MEMORANDUM

SUBJECT: Revisions to the Committee's *Report of the Southern Community Park Conceptual Plan Committee*

DATE: March 12, 2002

**Report of the
Southern Community Park
Conceptual Plan Committee**

MASTER PLAN

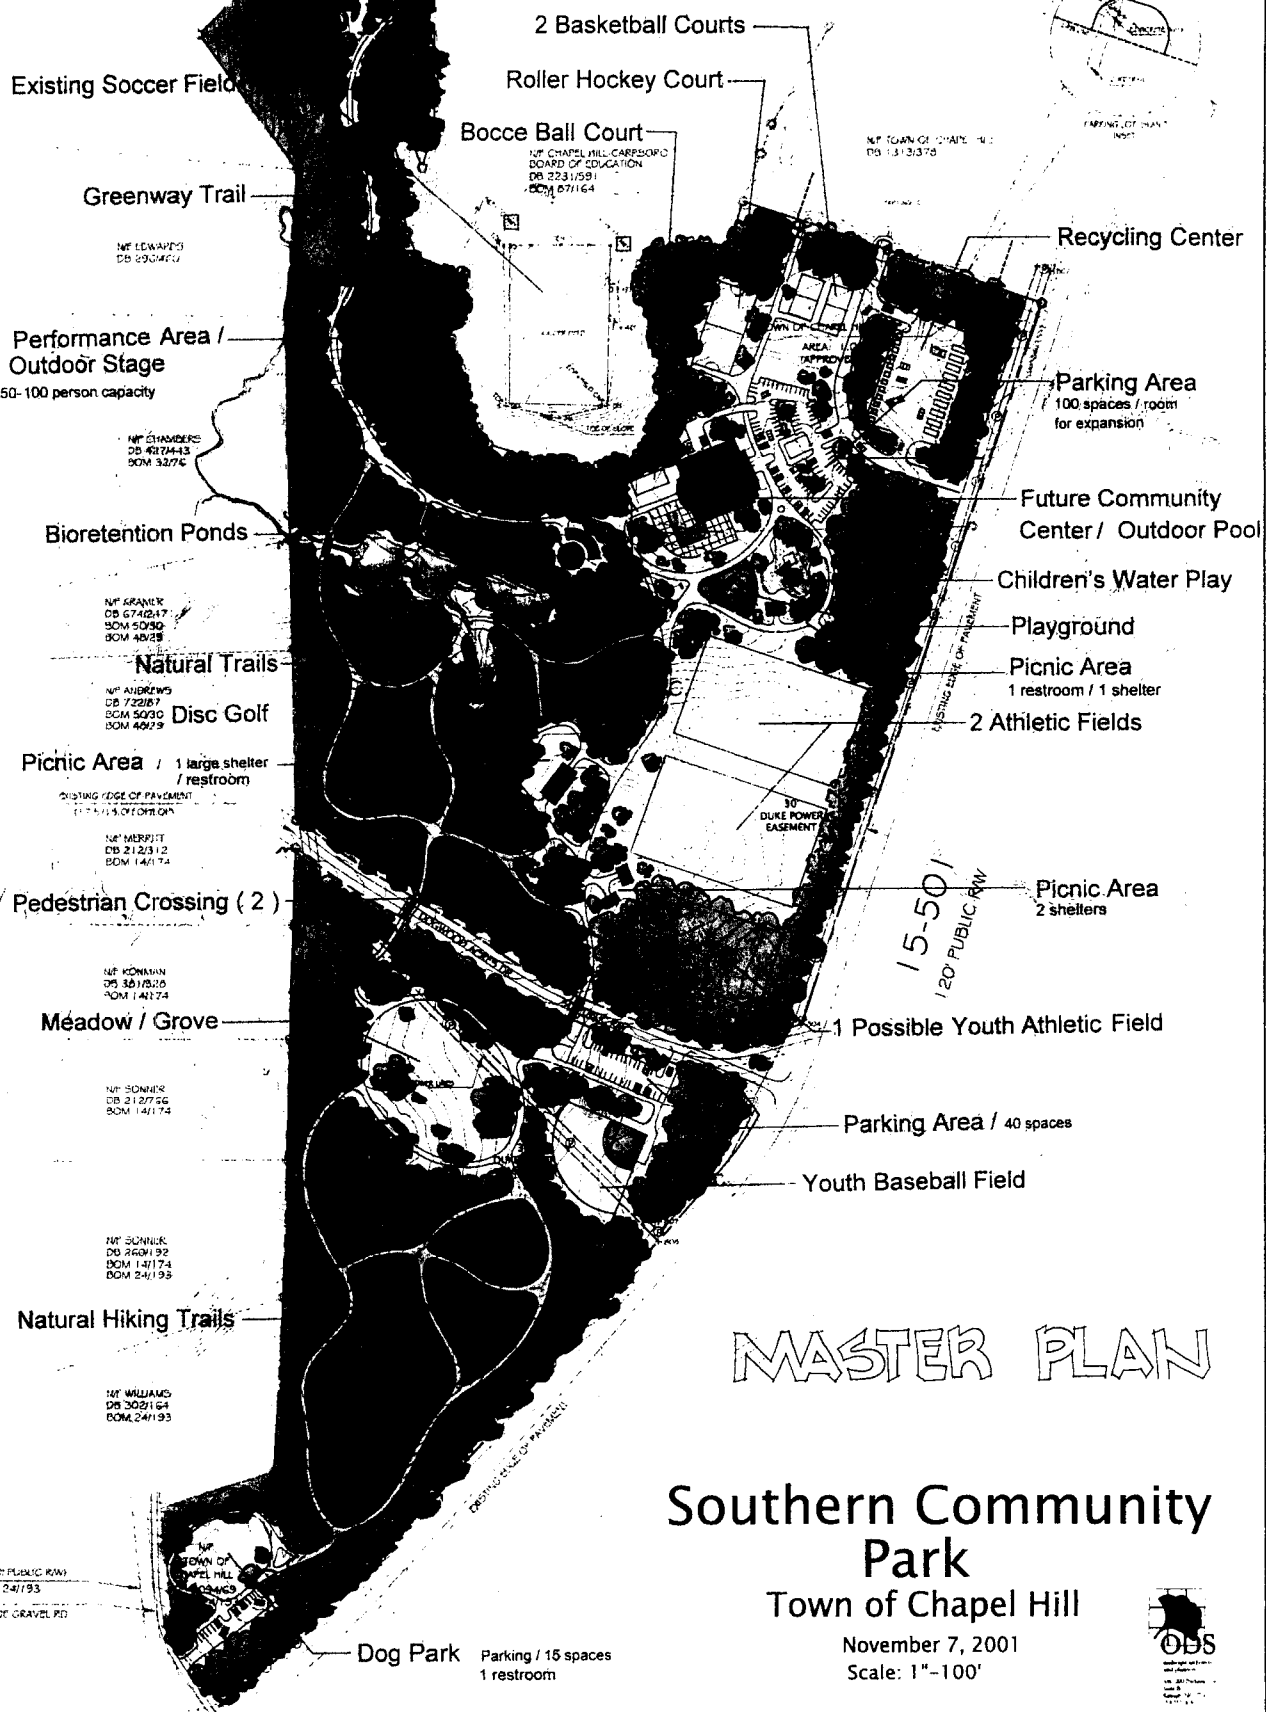
- The paved Fan Branch greenway trail should be extended to the southern tip of the park. The Committee specifically recommends that the trail extension should be near the eastern property line and parallel to Highway 15-501. The Committee recommends that the rest of the trails south of Dogwood Acres Drive remain unpaved.

- The plan should show better pedestrian connections to Scroggs School and the park and ride lot.
- A paved trail for improved pedestrian connection should be added along the north side of Dogwood Acres Drive, from the western property line to the point where the Fan Branch greenway trail crosses Dogwood Acres Drive.

- The site of the future community center should be designated as a temporary picnic area.
- The Town should maintain at least a 50 foot buffer along 15-501. The buffer could be enhanced with plantings where needed.

- The plan should address the importance of bus access and stops. Exact locations of bus stops should be addressed in the Special Use Permit phase of the project.

- The need for benches should be noted.
